# 1966 Corvette: Service News: Corvette Heavy Duty Brakes - Introduction

**Subject:** Corvette Heavy Duty Brakes

**Model and Year:** 1966 Corvette with RPO J56 Heavy Duty Brakes

**Date:** May 1966 - Volume 38 - Number 5

Fig. 3—1966 Corvette Heavy Duty Brakes (RPO J56)

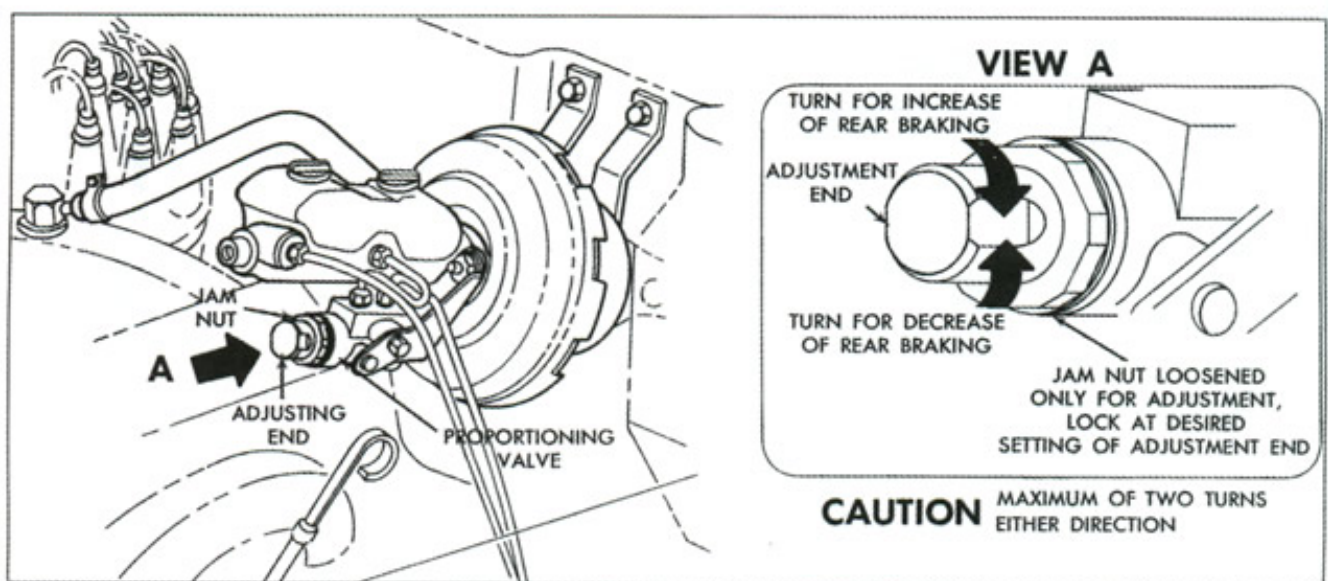
## REAR BRAKE PRESSURE REGULATOR VALVE OR PROPORTIONING VALVE (SEE FIG. 3)

The rear brake pressure regulator valve, or proportioning valve, is peculiar to the 1966 heavy duty option. The purpose of this valve is to provide balanced braking action between the front and rear brakes under a wide range of braking conditions.

The proportioning valve is factory-adjusted for optimum heavy duty use and no further adjustment should be required. The user may find, however, that different front-to-rear proportioning is desirable under certain conditions. With the large jam nut loosened, turning the large threaded end IN will effectively INCREASE the percentage of rear braking: turning it OUT and DECREASE the percentage of rear braking. Tighten the large jam nut to a

torque of 40 to 50 ft. lbs. after making any adjustments. Under no circumstances should the large threaded end be turned more than two (2) full turns in either direction, as this will render the valve inoperative.

Disassembly of the proportioning valve is not recommended: should it fail to perform properly, replace it with the service valve part #3878944.
